MEMORANDUM

DATE: January 21, 2011

REVIEW TYPE: Preliminary Plan of Subdivision

PROJECT NAME: Hidden Hill
CASE #: 120100180
REVIEW BASIS: Chapter 50, Montgomery County Subdivision Regulations

Figure 2

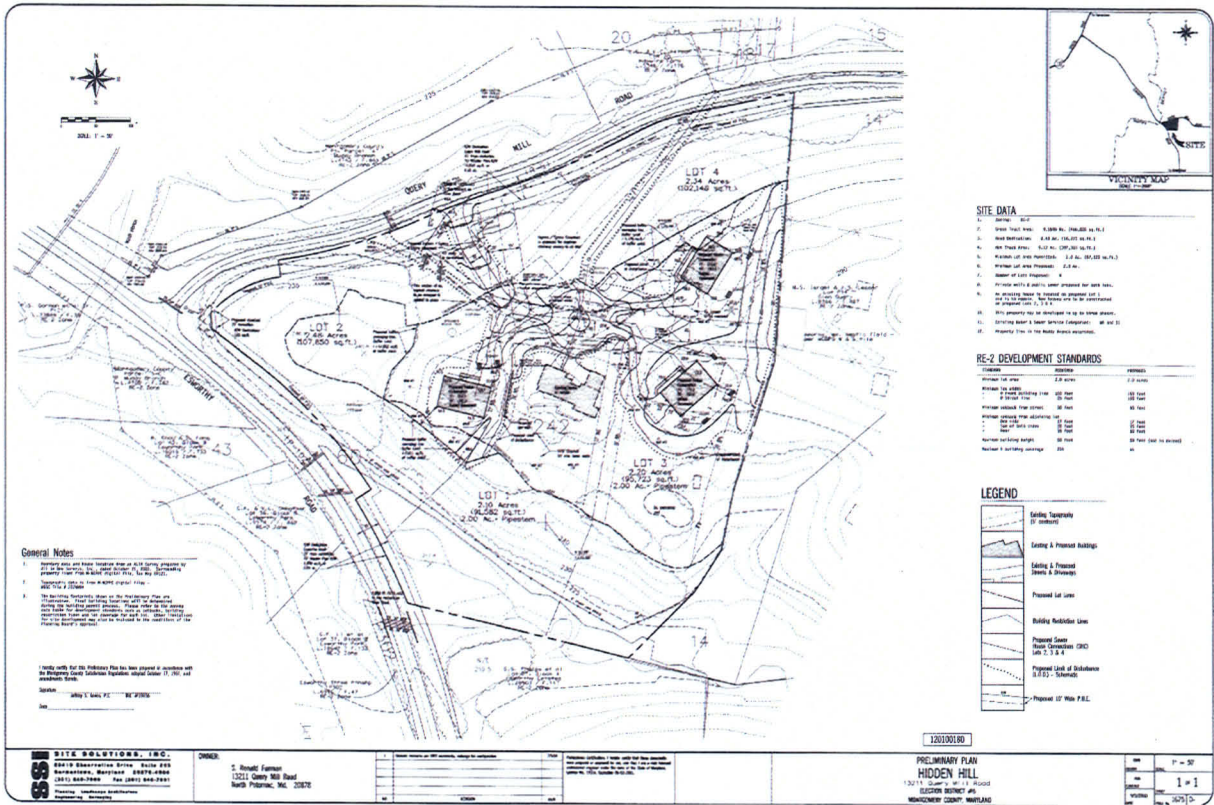
The proposed plan indicates 8,749 square feet of stream buffer encroachment; however the two areas proposed for encroachment are currently unforested. The encroachment is being requested to allow the homeowners to create usable outdoor space and accommodate well sites for water service. Placing a Category I conservation easement over these areas would restrict some of the activities that are usually related with single family homes including wells sites for water service. The amount of encroachment being requested has been minimized; only the amount needed to achieve the goals requested above were proposed for removal.

The areas of SVB encroachment include 2 out of the 3 required well sites (primary and two reserves) for each of the proposed lots. Alternate house and lot layouts were reviewed as part of the process, and the current layout works best for all agencies involved and helped reduce the amount of forest clearing. All reasonable alternatives had additional negative impacts to the environment, and staff believes this layout with the buffer averaging and proposed mitigation is a better comprehensive approach for protecting the environmental resources.

The encroached stream buffer area does not contain any steep slopes, forest, and it does not impact any wetlands, rare threatened and endangered species habitat, or any state mandated buffers. However, the area of SVB encroachment on proposed lot 4 does contain a specimen tree (tree #4) which is shown to be saved.

The applicant is proposing to mitigate the stream buffer encroachment by planting 1.14 acres of unforested stream valley buffer in excess of the planting requirements (0.36 acres) and to help mitigate for specimen tree loss (0.32 acres). This area of stream valley buffer would not otherwise be required to be planted, but would be shown as an area of natural regeneration on the forest conservation plan. Accelerated reforestation of the stream valley buffer increases the functionality of the stream valley buffer and speeds up the establishment of forest cover while helping to reduce invasive species encroachment.

After reviewing the plan and considering all five factors above staff believes the applicant's proposal is consistent with a comprehensive approach to protecting environmentally sensitive areas while remaining flexible with proposed uses. Staff recommends the applicant be permitted to permanently encroach into the stream buffer with the mitigation shown on the forest conservation plan.
